The USDA Forest Service (FS) received the Final License Application (FLA) for the DeSabra-Centerville Hydroelectric Project, Federal Energy Regulatory Commission (FERC) Project No. 803 (Project), from the Pacific Gas and Electric Company (Applicant or PG&E) on October 9, 2007. Although the Applicant filed the FLA with the Commission on October 2, 2007, many studies had not yet been completed, including: 6.3.2-4 Develop Water Temperature Model..., 6.3.2-5 Measure and Evaluate Water Quality..., 6.3.3-4 Characterize Fish Populations..., 6.3.3-6 Assessment of Fish Entrainment and Upstream Fish Passage..., 6.3.3-3 Assessment of RT&E Amphibian and Aquatic Reptile Species..., and 6.3.8-2 Traditional Cultural Properties. The Applicant has now provided supplemental study information on these studies and considers the FLA and associated studies to be complete or substantially complete.

Re: DeSabra-Centerville Hydroelectric Project Water Temperature Modeling

Subject: Review Comments on CE-QUAL-W2 Models for DeSable Relicensing Project – Forest Service Agreement No. 08-IA-11050650-016

**on the PG&E March 2008 Results of Study Plan:
6.3.3-3 Assessment of RT&E Amphibian and Aquatic Reptile Sp

Figure 1. Centerville Canal W2 model error during the summer and early fall in the 2004 calibration simulation.

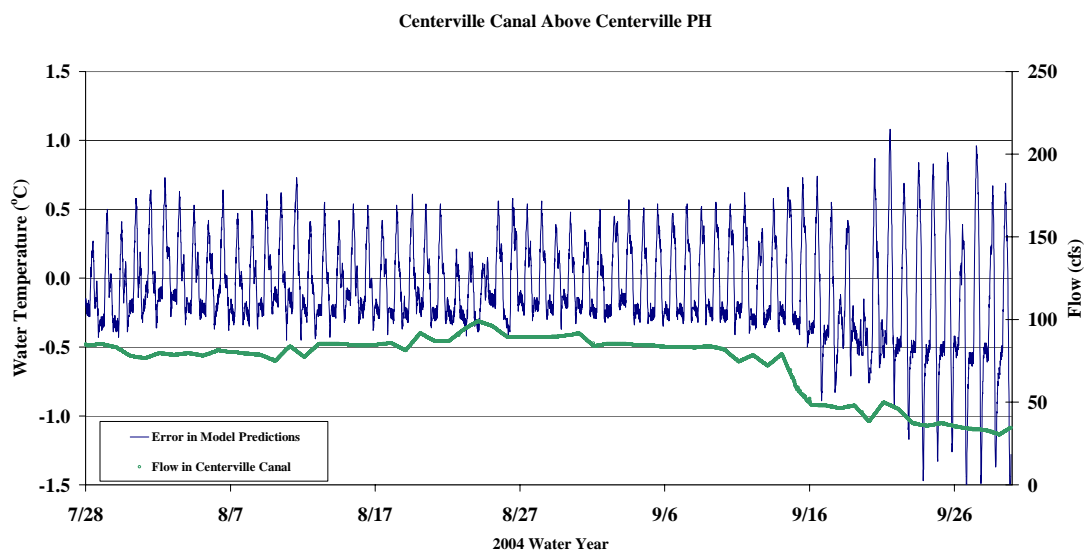
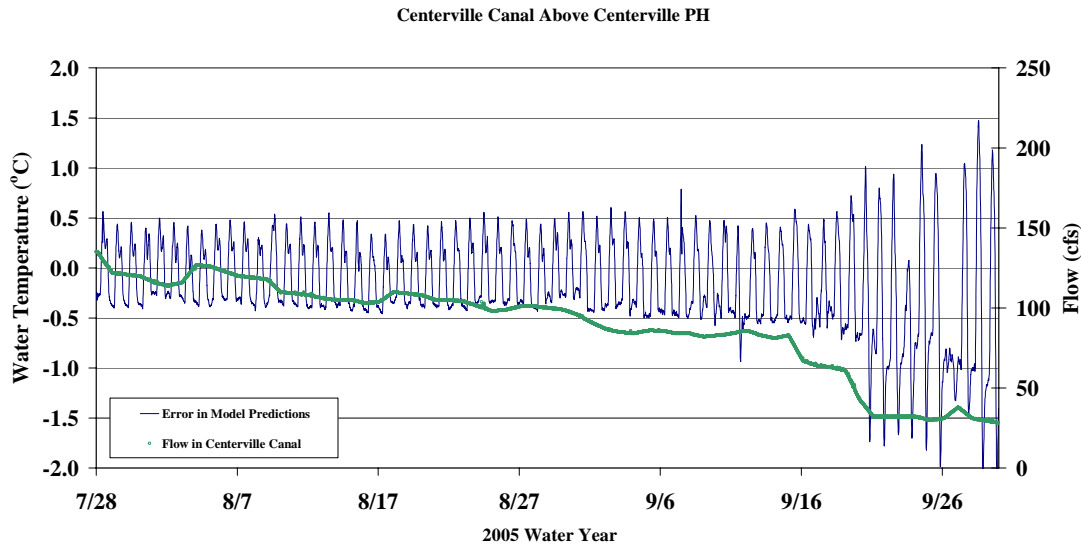
Figures 1 and 2 depict model¹ error vs. canal flow for the Lower Centerville Canal during the last half of the 2004 and 2005 calibration years, respectively. As can be seen for both the 2004 and 2005 calibration years, model error generally increases beyond $\pm 1^\circ\text{C}$ at flows below about 35 cfs. We also note that this pattern of increased model error seems to occur during the mid- to late-September period during both calibration years. The range of flows used in the calibration simulations was between about 28 cfs and 160 cfs. Therefore, we recommend that the Lower Centerville Canal model only be used to evaluate the differences in operational scenarios with flows between 35 cfs and about 160 cfs. In addition, the simulation period should be limited to early-June through mid-September.

- The models should be used for comparative purposes only (i.e. to compare the difference between operational alternatives);
- The Lower Centerville Canal model can be used to evaluate scenarios that include diversion flows between 35 cfs and 160 cfs. The simulation period should be limited to early-June through mid-September;
- The Hendricks Canal model can be used to evaluate scenarios that include diversion flows between 43 cfs and 236 cfs; and
- The lower Butte Creek model can be used to evaluate scenarios that include flows below the Centerville Diversion Dam between 24 cfs and 118 cfs.

Figure 3. Butte Creek W2 model predictions and observed temperatures during early summer in the 2004 calibration simulation.

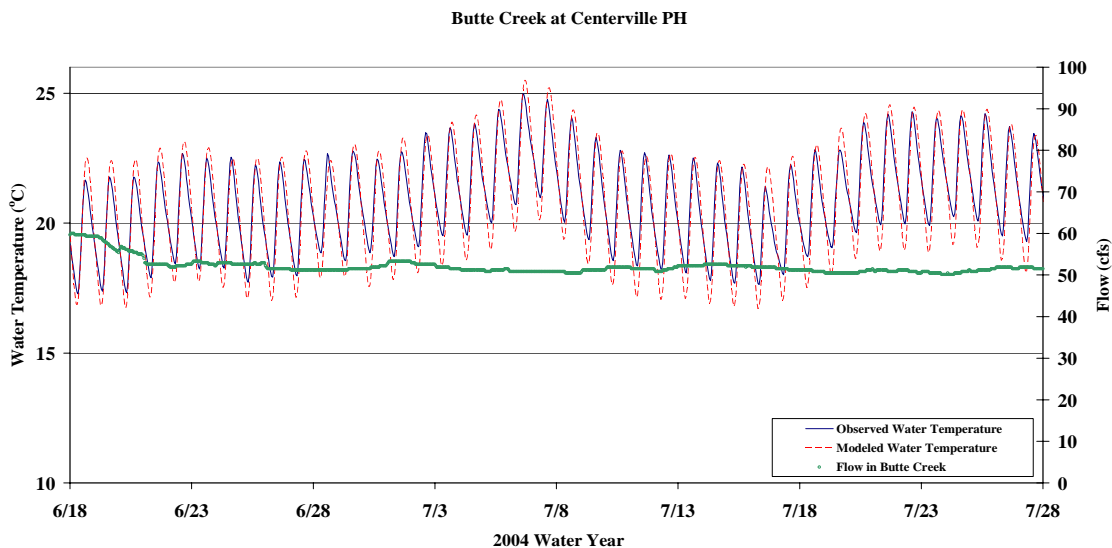
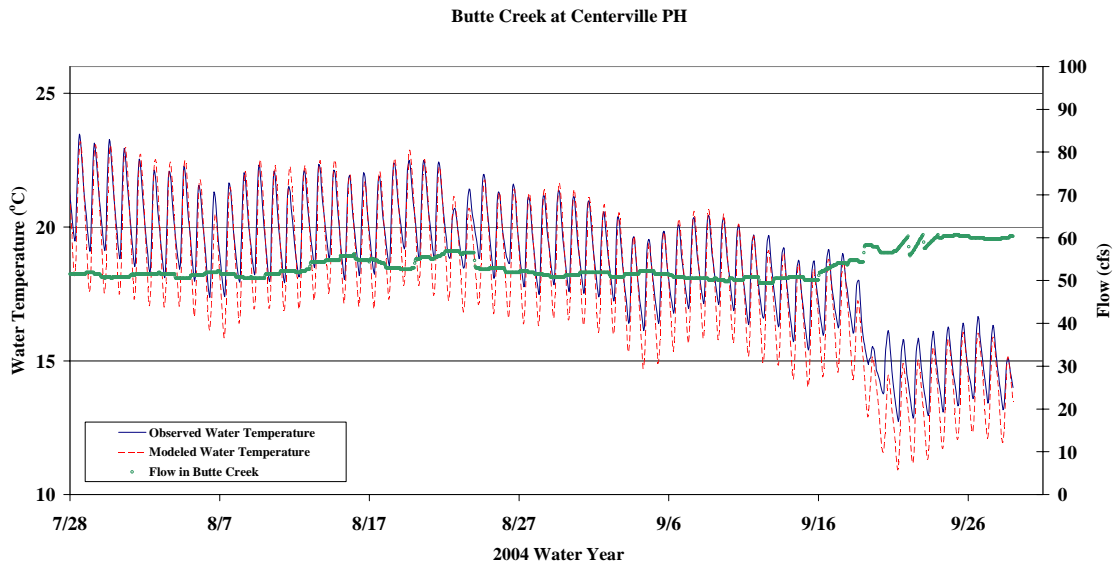
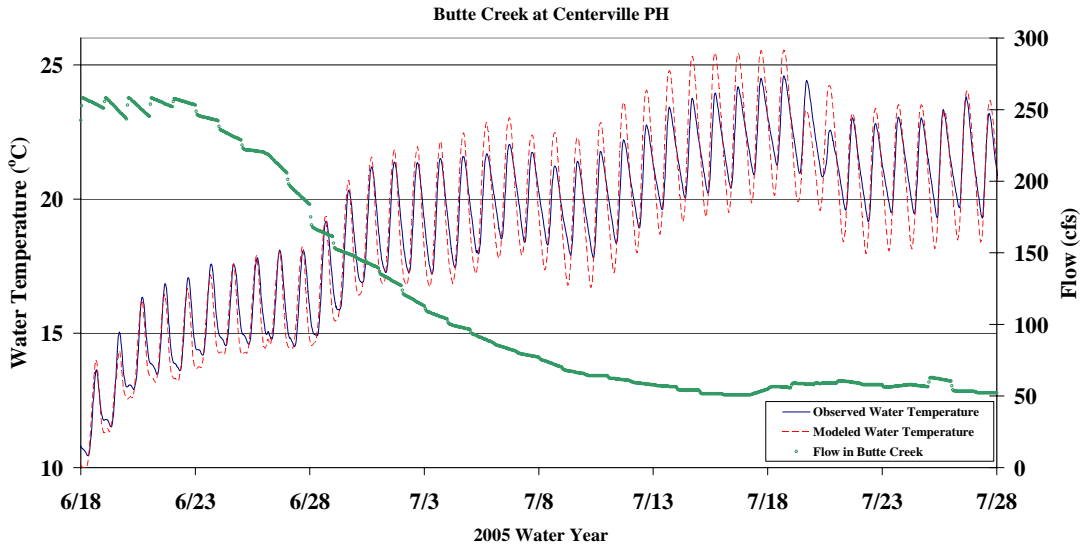
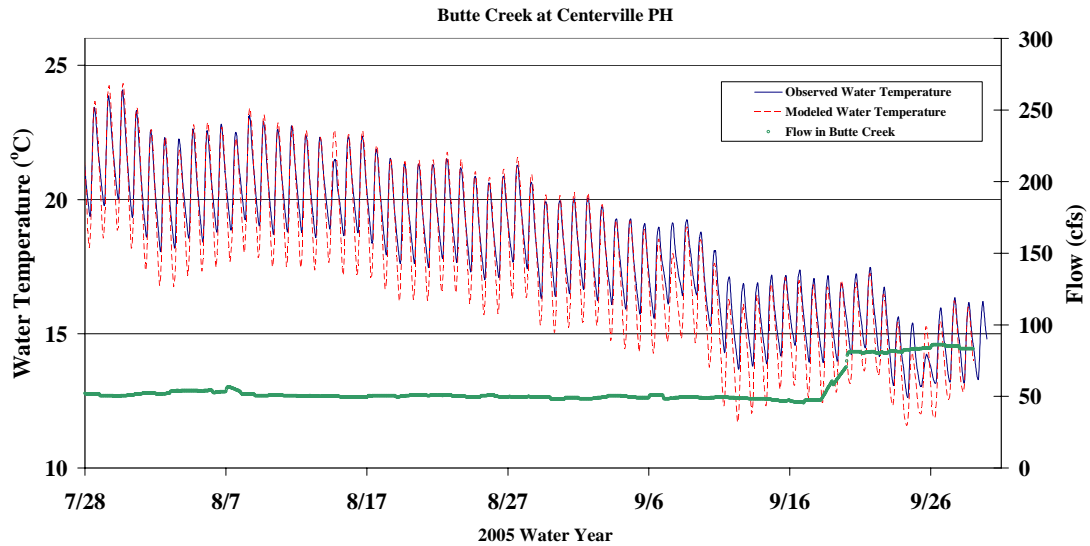
Figures 3 through 6 compare model output data, observed data, and flow data for lower Butte Creek during the 2004 and 2005 calibration years. As can be seen in both the 2004 and 2005 calibration years, the models appear to be specifically calibrated in an attempt to match maximum peak temperatures; however, the models appear to sacrifice accuracy with regard to the total amount of diurnal fluctuation and minimum temperatures. During the 2004 and 2005 calibration simulations, the flows in Butte Creek below the Centerville Diversion Dam ranged from about 43 cfs to about 236 cfs. Therefore, we believe that the models should be used to evaluate the differences in operational scenarios with flows between 43 cfs and about 236 cfs.

Figure 7. Hendricks Canal W2 model predictions and observed temperatures during the early summer in the 2004 calibration simulation.

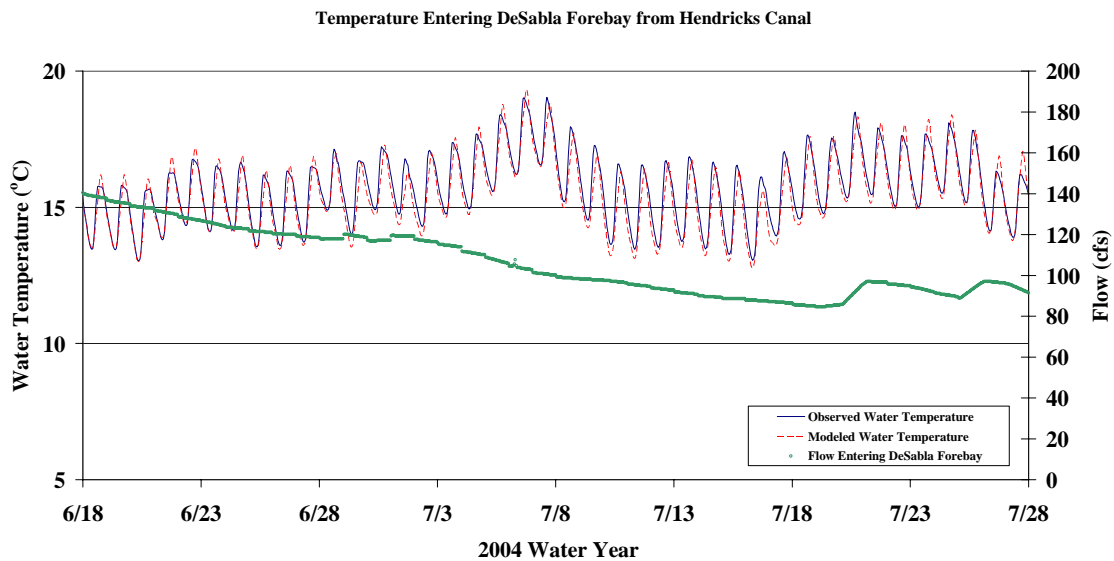
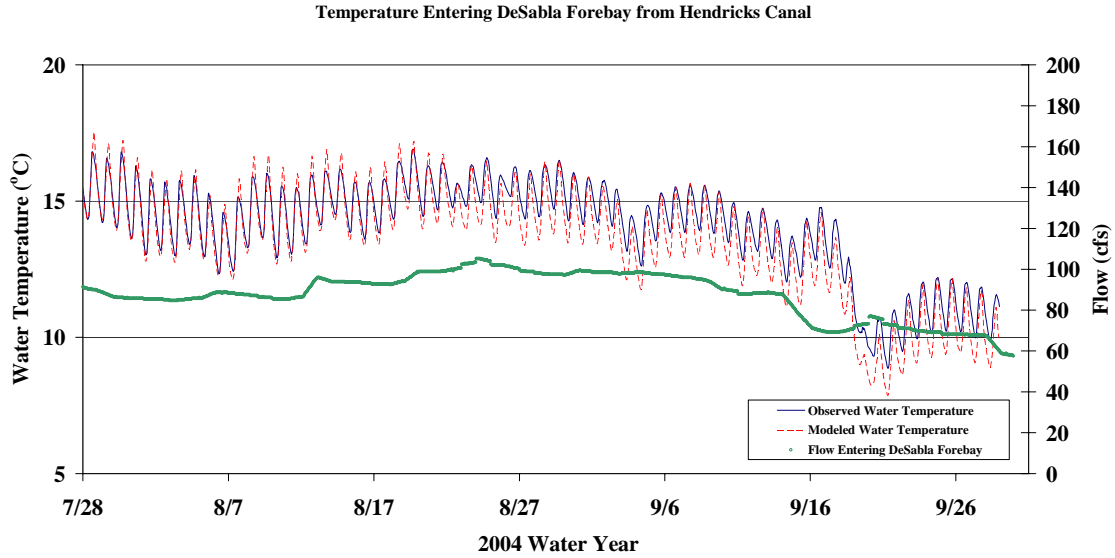
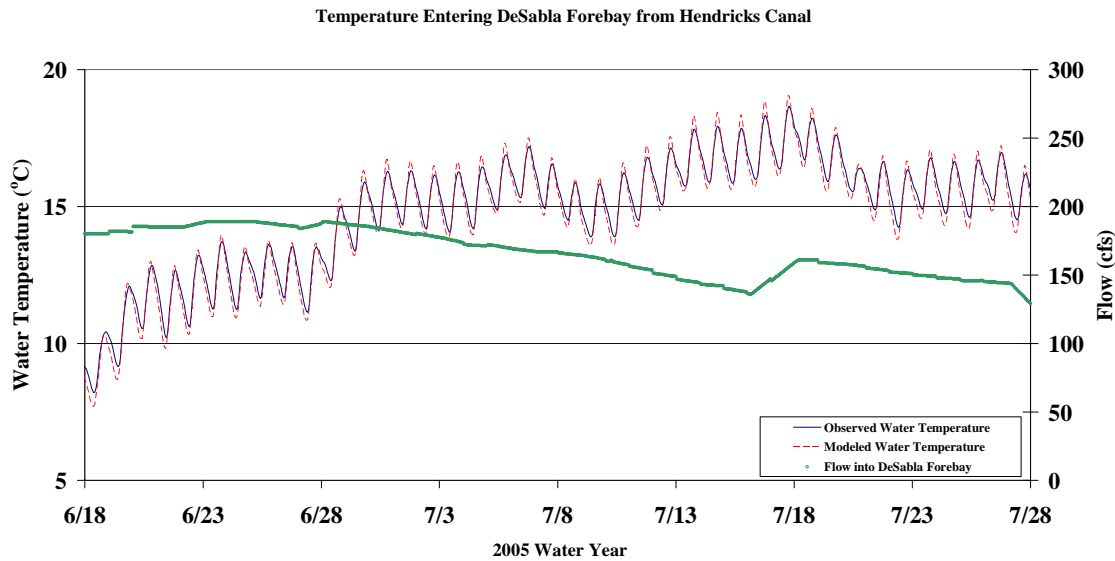
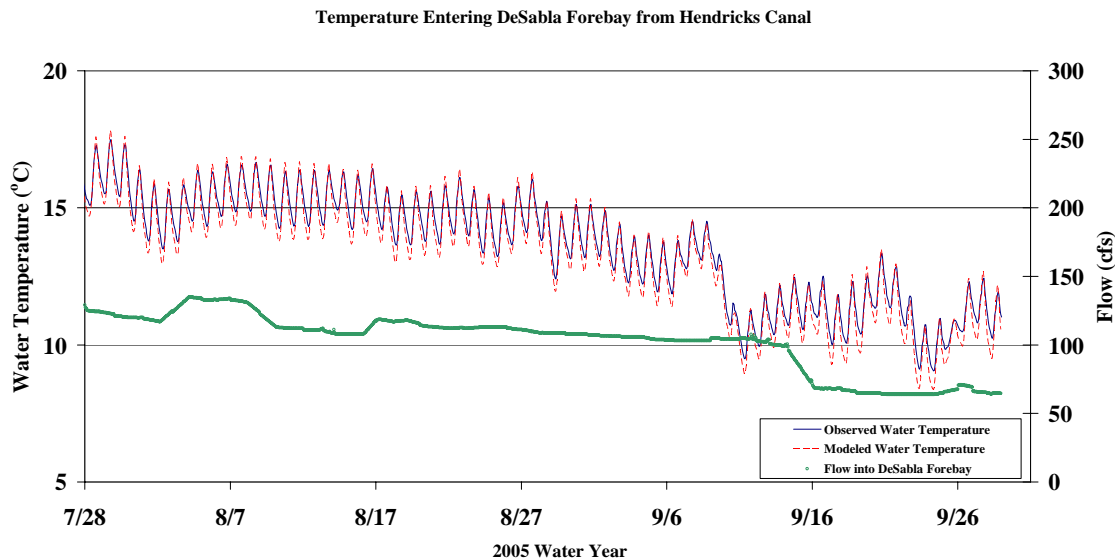
Figures 7 through 10 compare model output data, observed data, and flow data for the Hendricks Canal during the 2004 and 2005 calibration years. Similar to the lower Butte Creek models, the Hendricks Canal models appear to be specifically calibrated in an attempt to match maximum peak temperatures, and they appear to sacrifice accuracy relative to the total amount of diurnal fluctuation and minimum temperatures. During the 2004 and 2005 calibration simulations, the diverted flows ranged from about 24 cfs to about 118 cfs. Therefore, we believe that the models should only be used to evaluate the differences in operational scenarios with flows between 24 cfs and about 118 cfs.

Figure 11. 2005 temperature model predictions at the downstream end of the WBFR model.

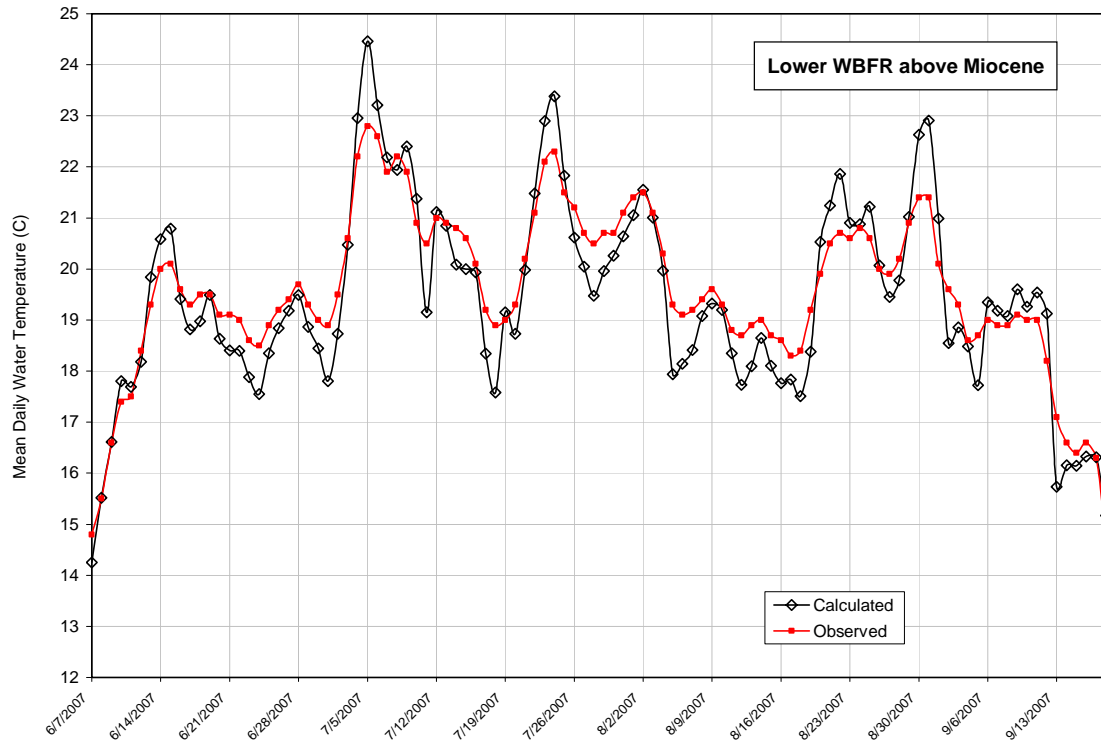
The Licensee did choose to revise the WBFR model in 2007. After the model was already calibrated/validated, the Licensee continued to collect data during 2007. When the field data for this dry year was input into the Lower WBFR model, the model did not meet the Licensee’s calibrations guidelines. The Licensee therefore developed a specific model for the WBFR during dry year conditions. In this model, the Licensee used a one-day lag in hydrology input conditions; this approach helped the Licensee bring the 2007 WBFR model’s performance to “near or within” their calibration criteria, however the model still continued to exhibit the exaggeration in temperature predictions. This trend is illustrated in Figure 11 below, which shows the measured and modeled temperatures at the Miocene diversion, on the downstream end of the Lower WBFR model.

Figure 12. 2005 temperature model predictions at the downstream end of the Upper Butte Creek model compared to flow releases (and spill) from the Butte Head Dam.

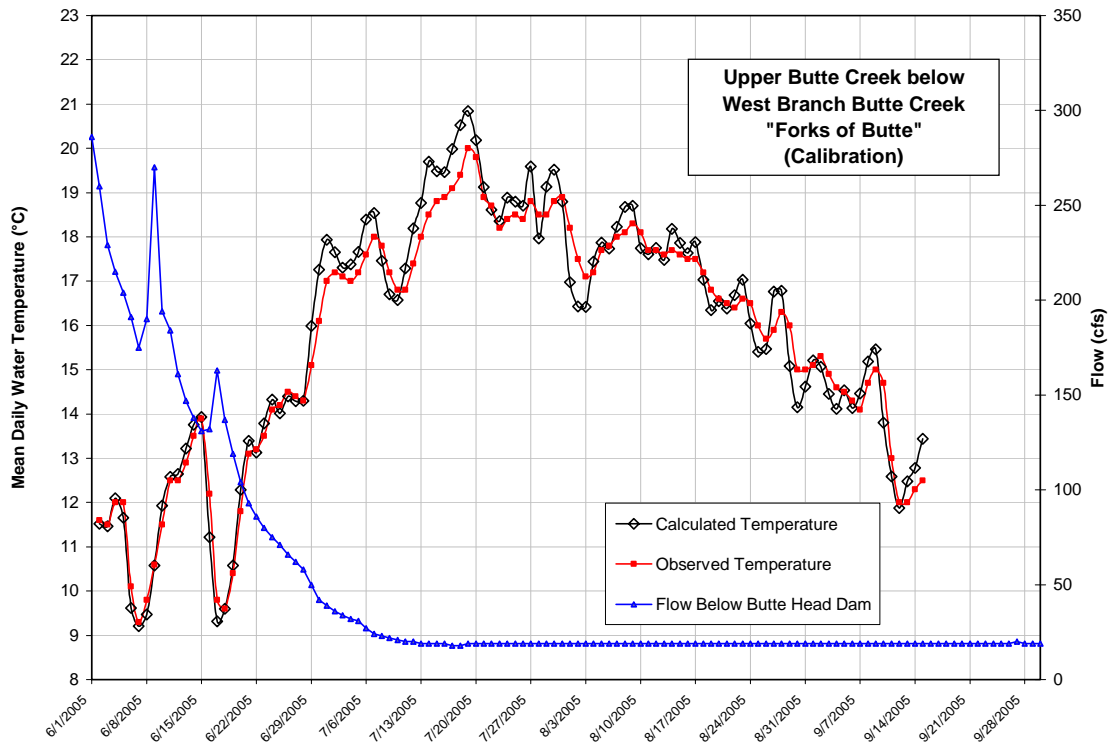
The hypothesis that the models perform poorly because of the low flow conditions is supported by consideration of the results of the one calibration model run that contains both high and low flows. Because releases are controlled at Butte Head dam and the Hendricks Head Dam, mostly only lower flow conditions were seen in the rivers during the simulation periods. However, during 2005 in the Upper Butte Creek model, higher flows were observed, and Figure 12 below shows that when flows at the top of the Upper Butte Creek reach were above about 50 cfs, the model performed well.

Figure 13. 2005 temperature model predictions at the downstream end of the Butte Canal model.

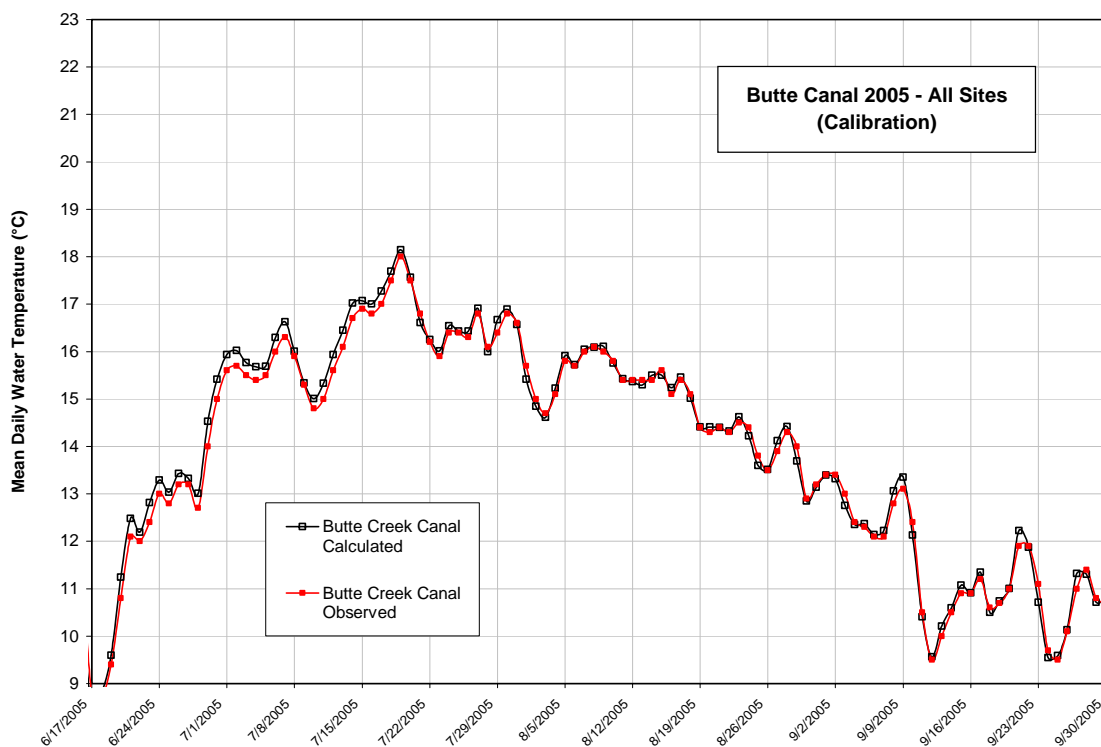
We also reviewed the Butte Canal model. The geometry in this model was represented simply as a rectangular channel, and this is probably not accurate. A more appropriate width versus flow relationship could be developed. However, the Butte Canal model does a good job predicting water temperatures throughout the summer at Dam release flows of 40-75 cfs. We recognize that there may be a lower limit on the ability of the model to accurately predict temperatures at very low flows, but we have no way to determine a lower limit on the model's range. While we don't have any specific recommendations for changes or limits on this model, we would caution that using this model for predicting water temperatures at flows much below 40 cfs is outside of the range of calibration. The performance of the Butte Creek model during the calibration year, 2005, is shown in Figure 13 below.

Figure 66: Model predicted water temperatures (flow weighted average from Models 9 and 10) compared with data measured at BC9, June 29th to July 19th, 2005.

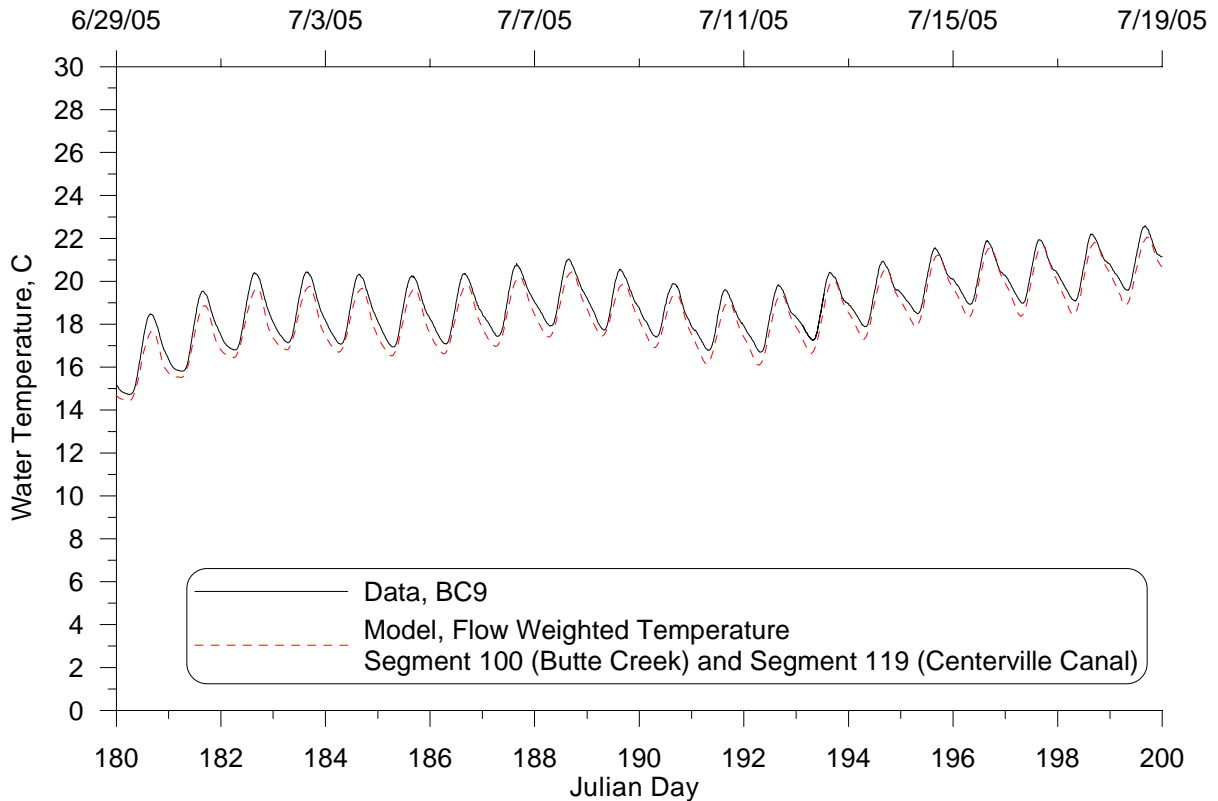
7) The following Figure 66 from the draft report, DeSabra-Centerville System Temperature Model: Model Update, by C. Berger, R. Annear, and S. Wells, January 2008 also shows some temperature differences and warm model results. However, overall the patterns track the observed warm temperatures sufficient enough for sensitivity analysis, planning, and appraisal level studies.
